Addendum #7

CONSIDER IN YOUR RESPONSE/BID THE FOLLOWING ITEMS OF ADDITION, DELETION OR CLARIFICATION. INDICATE IN THE SPACE PROVIDED ON THE RESPONSE/BID FORM THAT YOU HAVE RECEIVED AND INCLUDED FOR THE REQUIREMENTS OF THIS ADDENDUM. SICKKIDS MAY, IN ITS SOLE DISCRETION ANSWER SIMILAR QUESTIONS FROM VARIOUS RESPONDENTS ONLY ONCE.

RE: QUESTIONS AND ANSWERS, SPECIFICATIONS, DRAWINGS AND DOCUMENTS

2 LEVEL 2 - SPECT CT ROOM RENOVATION FLOOR PLAN

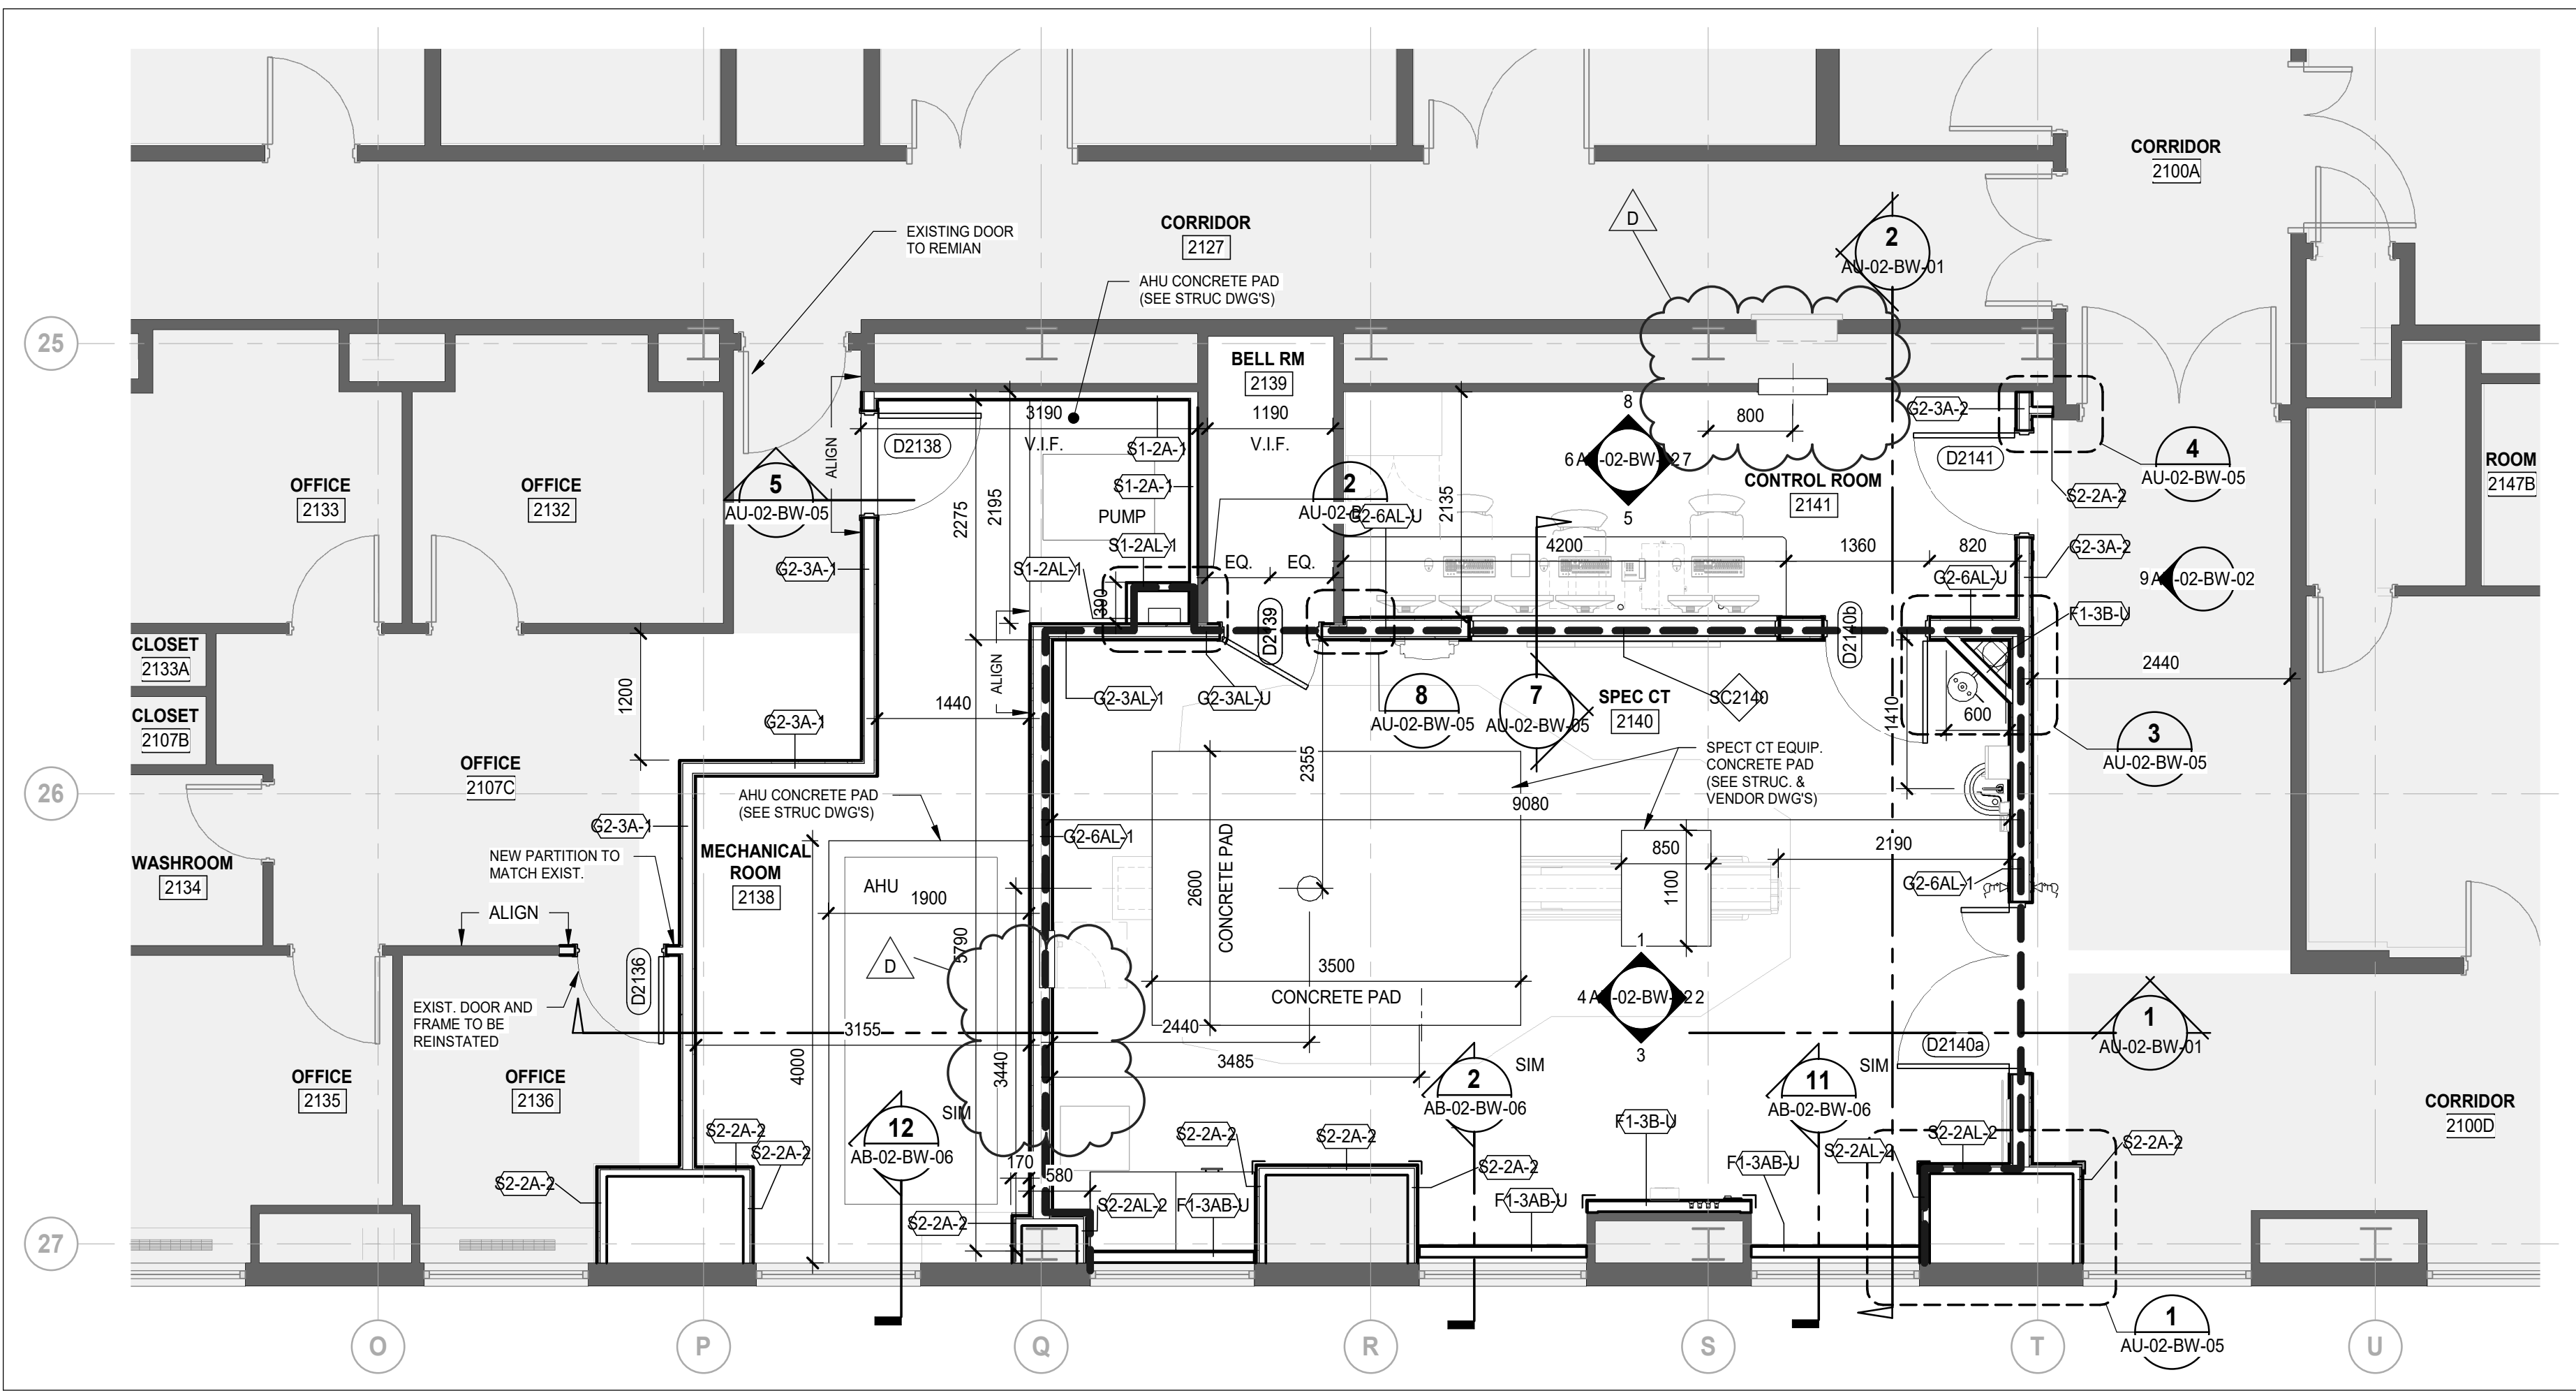
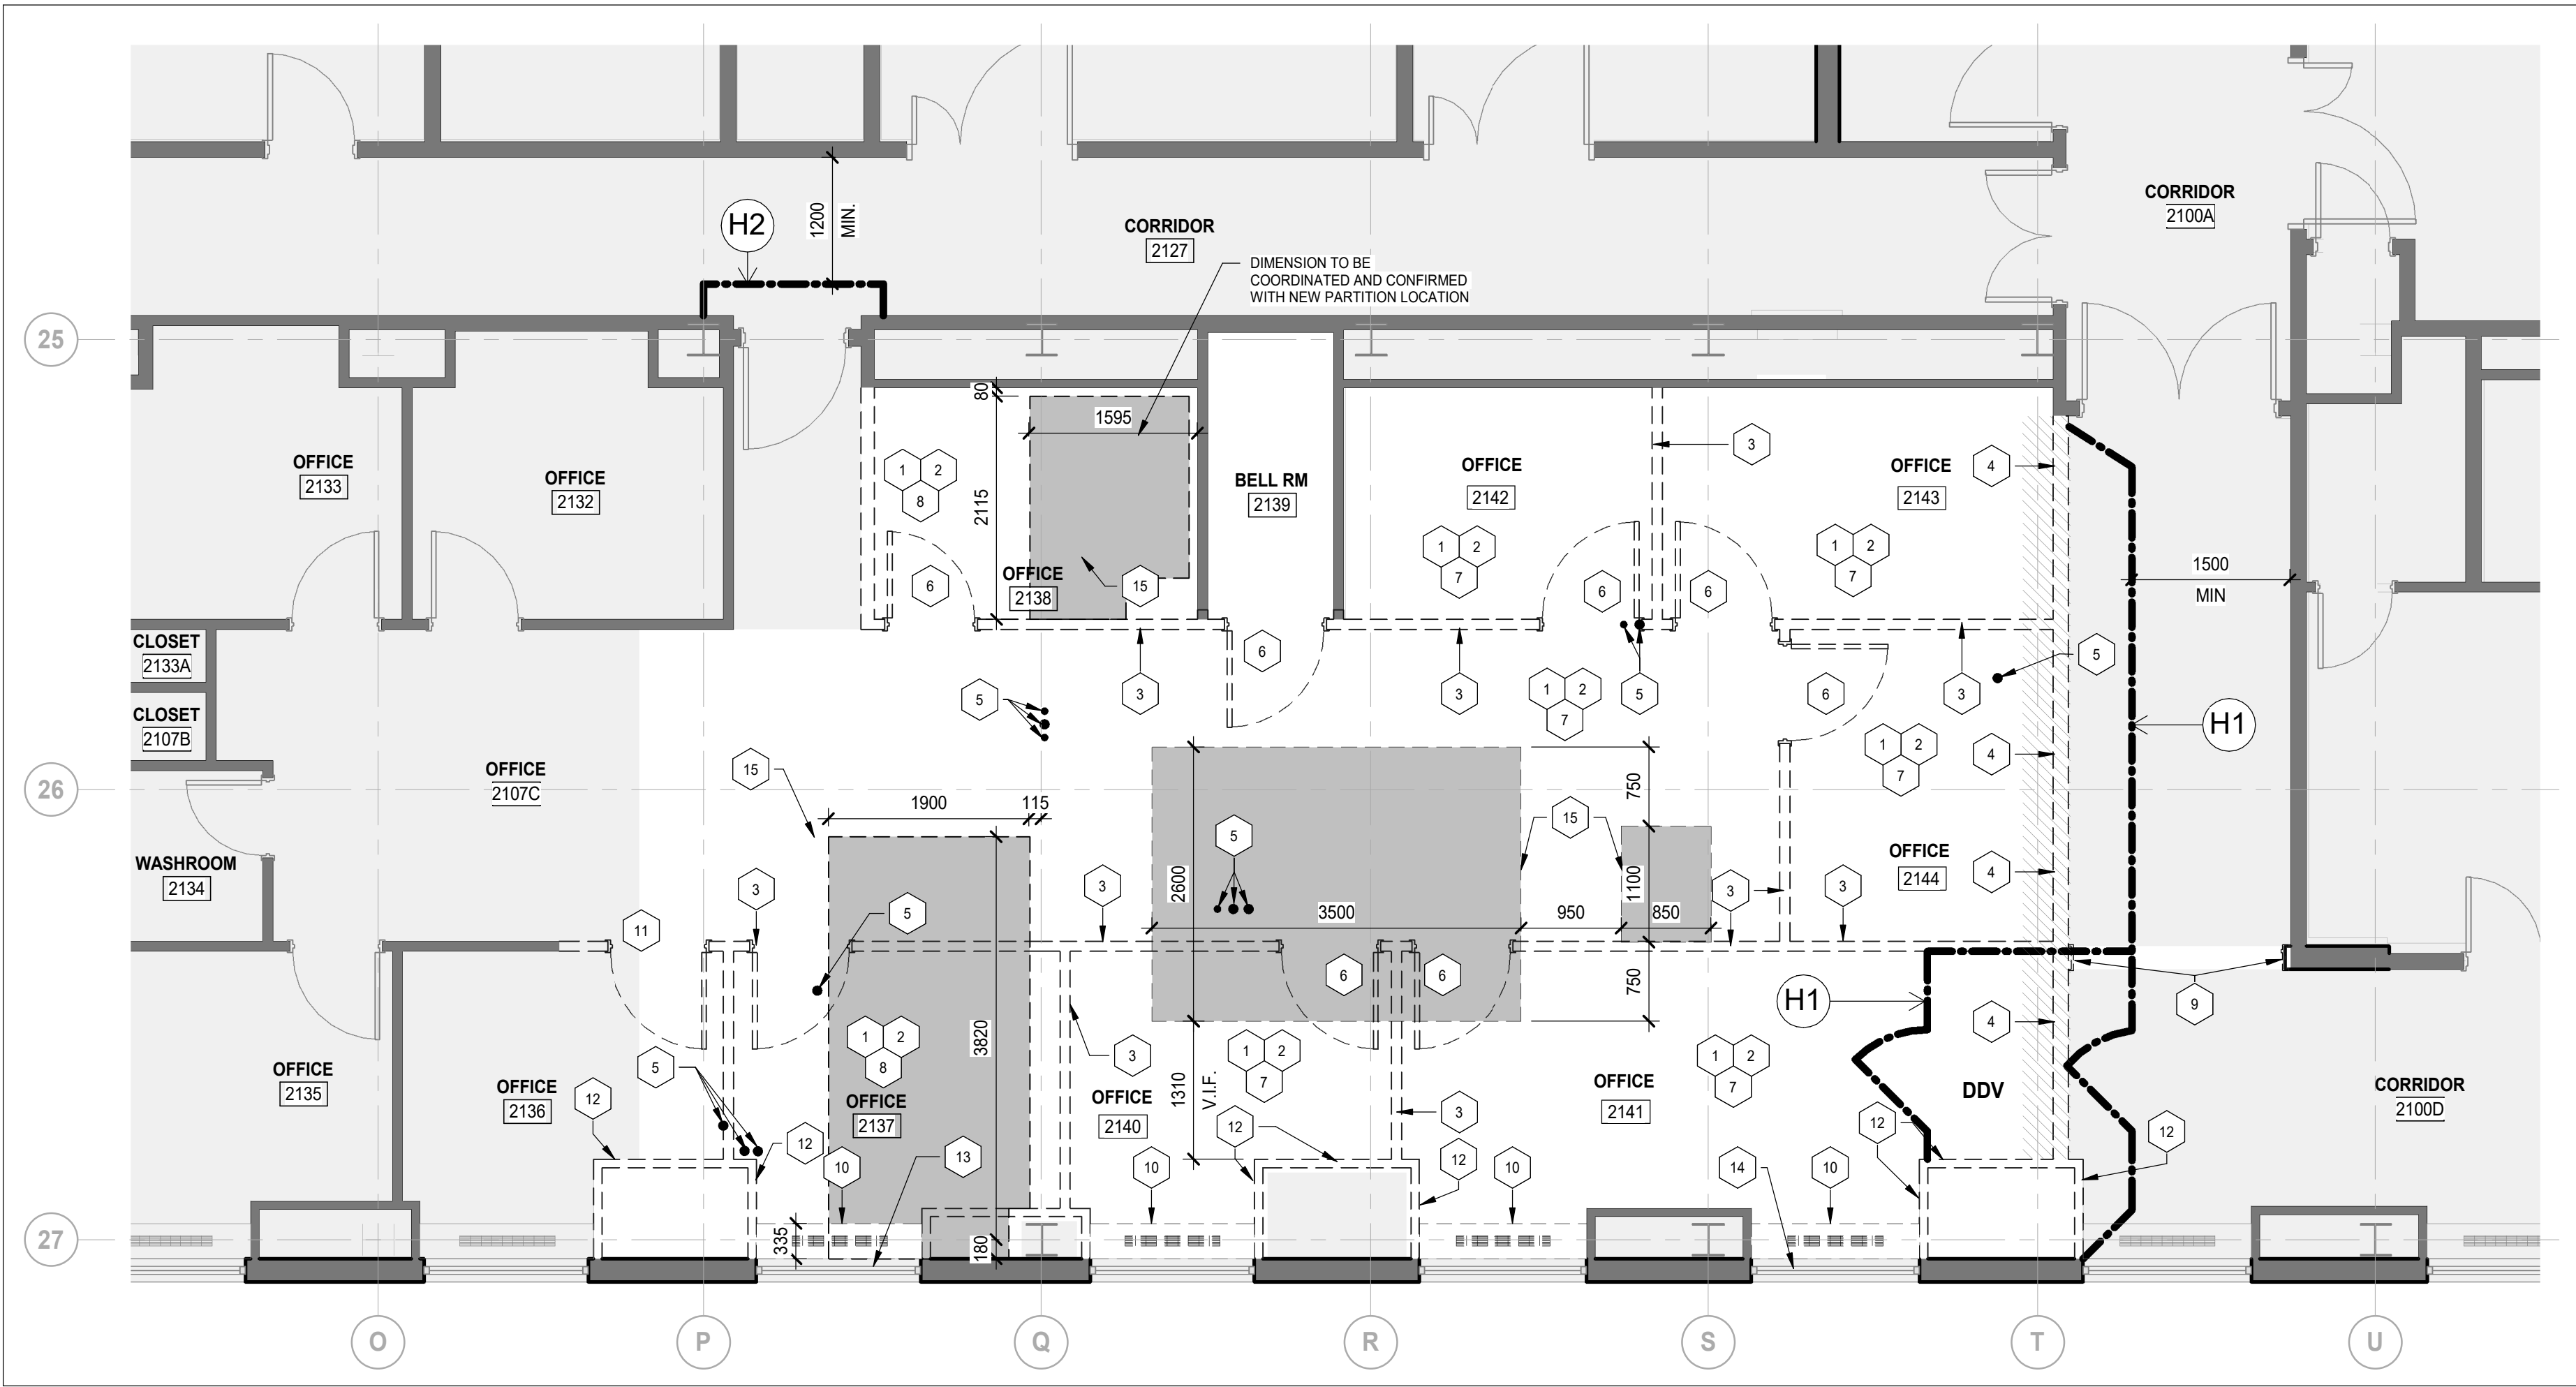
- .1 Drawing AB-02-BW-03 FIRE AND LIFE SAFETY, PLAN, OBC MATRIX, DOOR TYPES & SCHEDULE
Door Schedule revision.
 - .2 Drawing AF-02-B2-01 DEMOLITION AND SPECT CT ROOM RENOVATION FLOOR PLAN
Removed Valve Box and new location of Valve Box
